dsPIC33EPXXXGP50X, dsPIC33EPXXXMC20X/50X and PIC24EPXXXGP/MC20X Family Silicon Errata and Data Sheet Clarification

The dsPIC33EPXXXGP50X, dsPIC33EPXXXMC20X/50X and PIC24EPXXXGP/MC20X family devices that you have received conform functionally to the current Device Data Sheet (DS70000657J), except for the anomalies described in this document.

FIGURE 1: TIMING DIAGRAMS FOR CENTER-ALIGNED AND EDGE-ALIGNED MODES

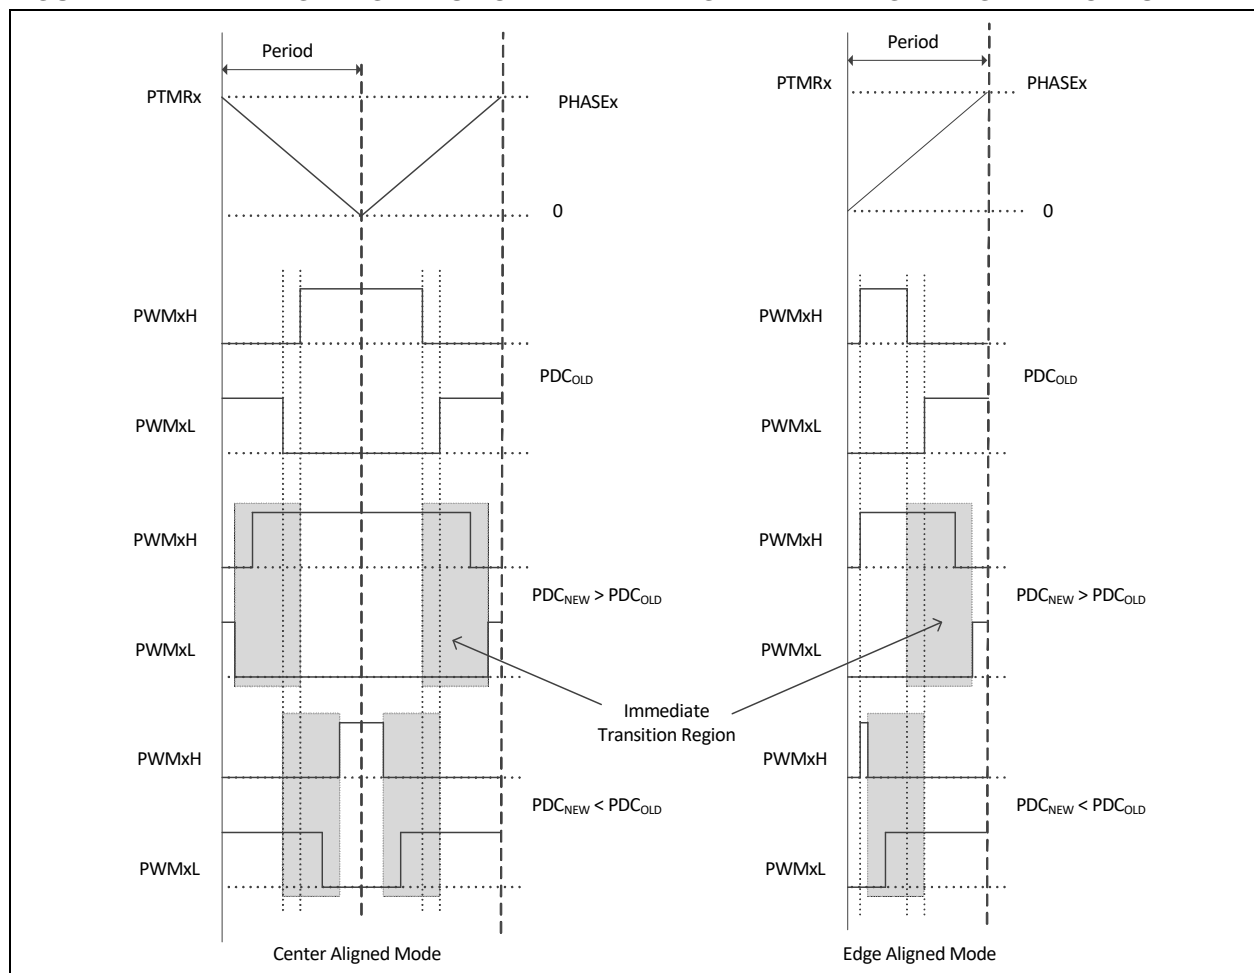
The PWM generator may not assert dead time on the edges of transitions. This has been observed when all of the following conditions are present:

- The PWM generator is configured to operate in Complementary mode with Independent Time Base (ITB) or master time base;
- Immediate update is enabled; and
- The value in the PDC register is updated in such a manner that the PWMxH and PWMxL outputs make an immediate transition.

In [Figure 1](#), if the duty cycle write occurred in the shaded box, then PWMxH and PWMxL will make an immediate transition without dead time.

However, in most applications the duty cycle update timing can be controlled using the TRIGx trigger, or Special Event Trigger, such that the above mentioned conditions are avoided altogether.

FIGURE 2: PWM TIMING DIAGRAM

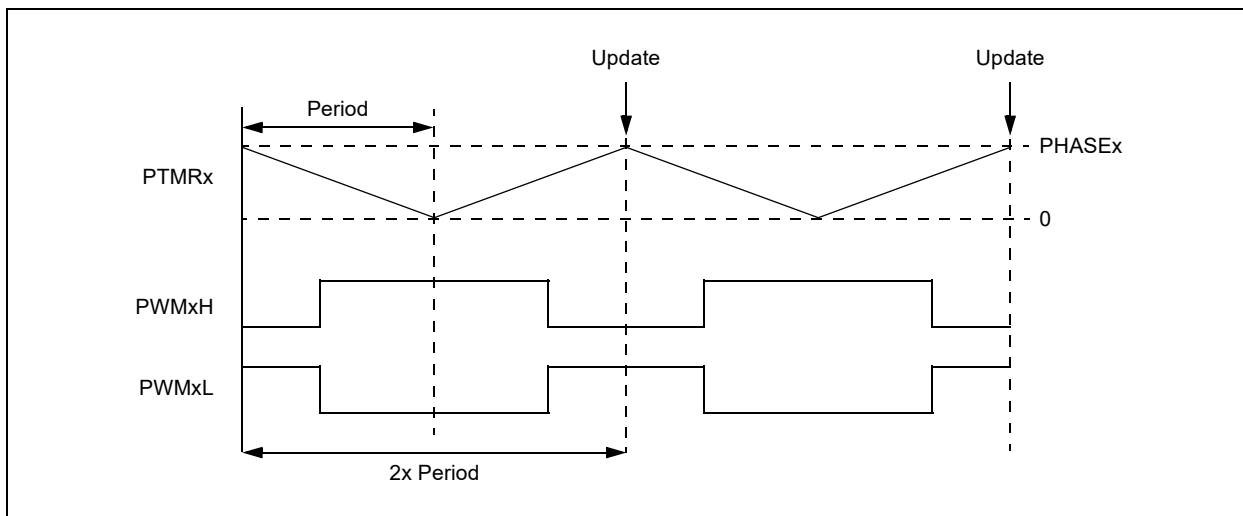
In Center-Aligned mode, updates to active `MDC/PDCx/ALTDTRx/PHASEx` registers occur only once every two PWM periods; that is, when the PWM timer matches the `PHASEx` register. In other words, the double update feature is not available. Figure 2 illustrates this relationship.

FIGURE 3: CORRECT AND INCORRECT POSITION COUNT CAPTURES

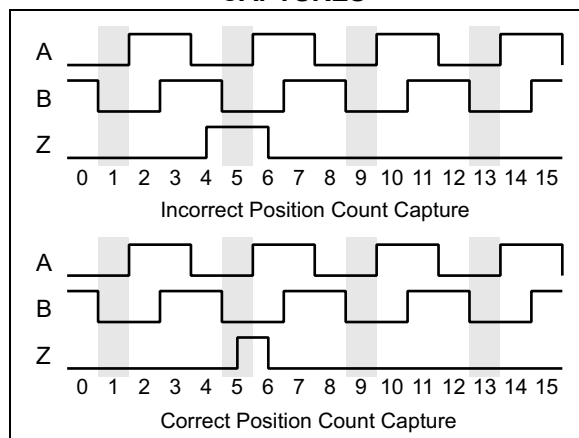
When index count position capture is being used (QE1IOC.QCAPEN = 1), the position count may be one more or one less than the correct value, depending on the direction of the count.

This is only observed when the leading edge of the index pulse occurs prior to the leading edge of the index match event. When the index pulse starts after the leading edge of the index match event, the position count is captured correctly.

Figure 3 shows how this occurs. In these cases, Encoder Signals A, B and (index) Z are shown, with the module being configured for index match when A and B are '0'. The effects of a correct and incorrect capture are shown side by side (shaded area indicates the index match event); the position count is shown along the bottom.

For encoder signals with timing that ensures the index pulse always starts prior to the start of the index match event (i.e., encoders with a non-gated index pulse), measure the direction of the encoder motion. If the encoder is counting up, add one to the captured position count; if the encoder is counting down, subtract one from the captured position count.

For encoder signals where the index pulse leading edge approximately coincides with the start of the index match event (i.e., encoders with a gated index pulse), a small delay can be added to the index pulse, for instance, by using a simple R-C filter.

FIGURE 4: PWM GENERATOR TIMING DIAGRAM

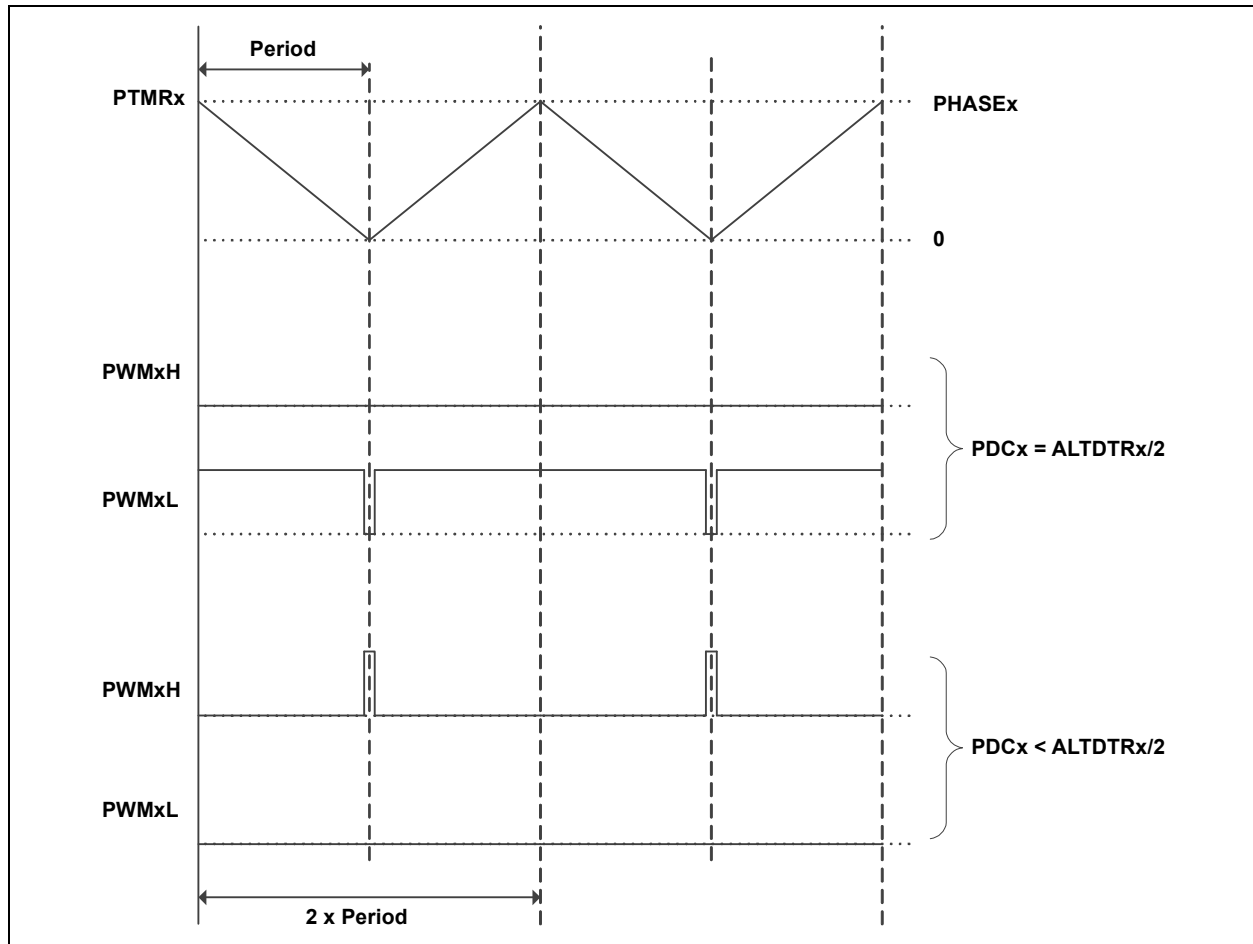
In Center-Aligned Complementary mode with Independent Time Base, if the value in the PDCx register is less than one-half the value in the ALTDTRx register, the PWM generator will force the PWMxL to low, and on the PWMxH, generate pulses of width less than twice the dead time, as shown in Figure 4.

FIGURE 5: ILLUSTRATION OF 1 T_{osc} GLITCH WHEN PWM OVERRIDE IS TURNED OFF

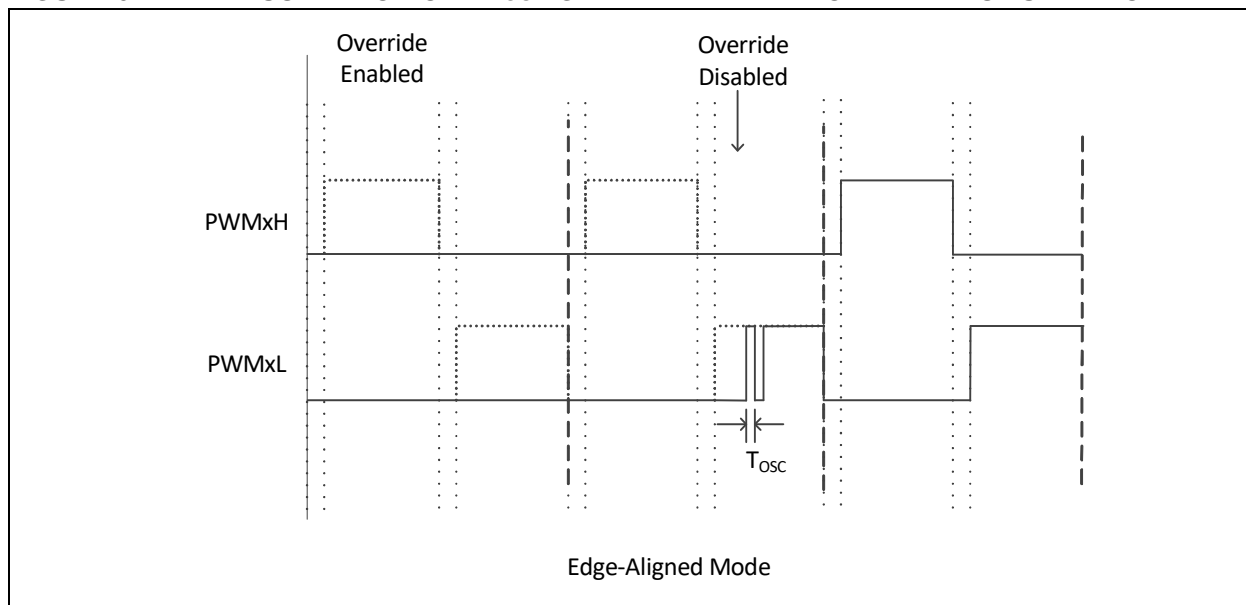
In Complementary mode after the PWMx module is enabled (PTEN = 1), if the PWM override is turned off, a 1 T_{osc} glitch will be present on the rising edge of either PWMxH or PWMxL, whichever occurs first, as shown in Figure 5. The glitch will be present on PWMxH/PWMxL every time the override state is changed from enabled to disabled. The width of this glitch is equal to 1 T_{osc} when PCLKDIV[2:0] = 000; increasing the PWM input clock prescaler setting will increase the width of the glitch accordingly.

FIGURE 6:

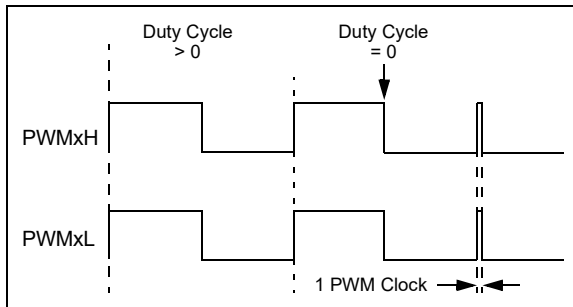
In certain output modes, the PWMx module produces a pulse glitch of one PWM clock in width (Figure 6). This has been observed only when all of the following are true:

- Either Redundant or Push-Pull Output mode is selected (IOCONx[11:10] = 10 or 01);
- Immediate Update is disabled (PWMCONx[0] = 0); and
- The value of the current Duty Cycle register (either the PDCx or MDC register, as determined by PWMCONx[8]) is updated to zero from any non-zero value.

The pulse glitch has been observed to occur at the beginning of the following PWM boundary period.

FIGURE 7:

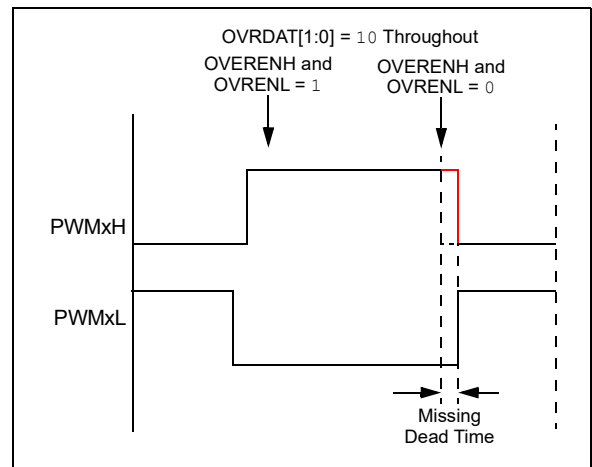
- Output override synchronization is configured to occur on the CPU clock boundary (IOCONx[0] = 0);
- Both PWMxH and PWMxL overrides are enabled prior to the event (OVRENH and OVRENL are both '1'), and
- Both overrides are disabled (OVRENH and OVRENL are both '0') at the instant the dead time should be asserted (Figure 7).

This has been observed in both Center-Aligned and Edge-Aligned modes.

FIGURE 8:

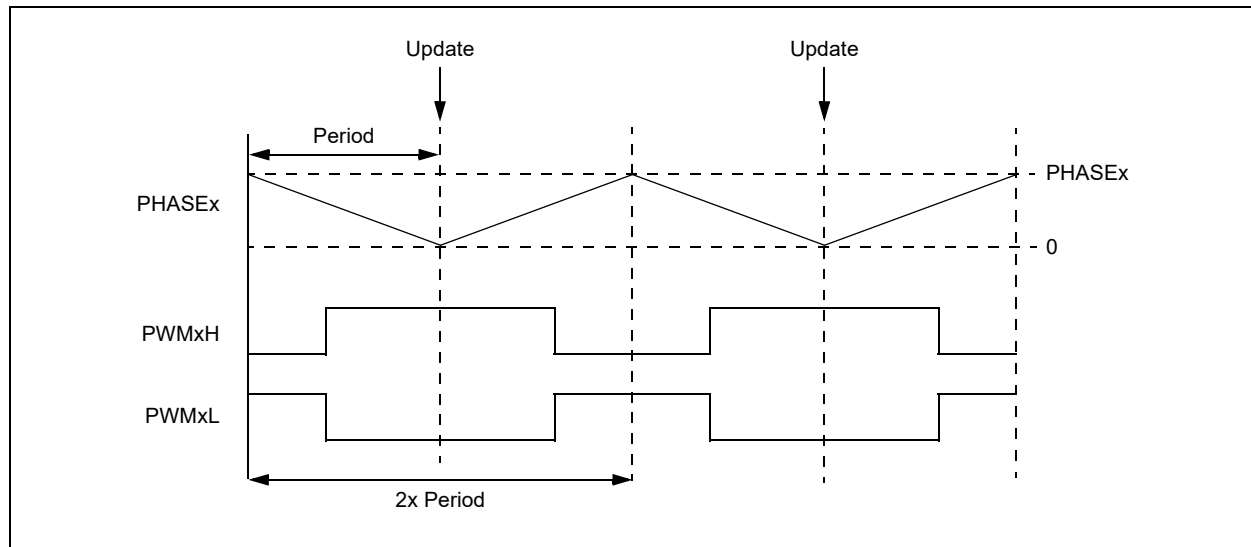
In Center-Aligned Complementary mode with Independent Time Base, updates to the PHASEx register take effect in the middle of a center-aligned PWM cycle, as shown in Figure 8. This occurs only when the Immediate Update feature is disabled (IUE = 0). If Immediate Update is enabled (IUE = 1), the PHASEx register updates will take effect immediately.

FIGURE 9: SIMPLIFIED BEHAVIOR

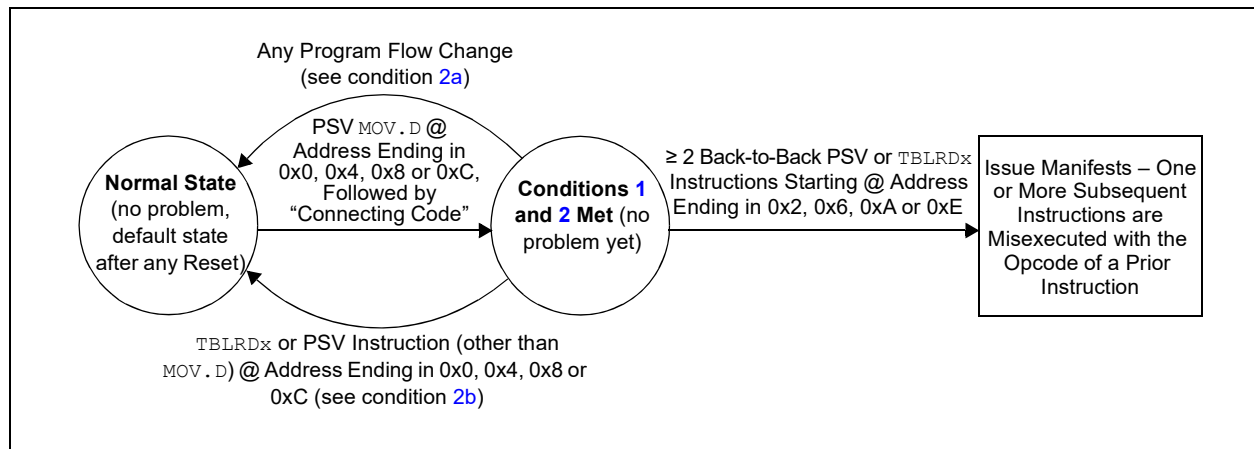
3.	≥ 2 back-to-back PSV or <code>TBLRDx</code> instructions are executed (following the code of condition 2), where the first of the back-to-back instructions is located at an address ending in 0x2, 0x6, 0xA or 0xE.

[Figure 9](#) provides an example of the effective behavior.

1. All instances of PSV `MOV.D` can be replaced with two PSV `MOV` instructions instead. Non-PSV `MOV.D` instructions acting on RAM/SFRs do not need to be modified; or
2. If not already present, a program flow change instruction (such as `BRA $+2`) can be inserted above back-to-back data Flash read sequences; or
3. Back-to-back data Flash read instruction sequences can be broken up by inserting a non-Flash read instruction (such as a `NOB`) in between the Flash read instructions; or
4. The alignment of the code can be shifted to avoid the required opcode location addresses.

C code built with MPLAB® XC16 Compiler, Version 1.32, or later, implements the work around by default. However, if the application uses Assembly language routines, these should be manually modified to implement the work around. Additionally, if precompiled libraries are used, these should be built with XC16 Version 1.32 or later. For additional information, please visit: www.microchip.com/erratum_psrds_psrds.
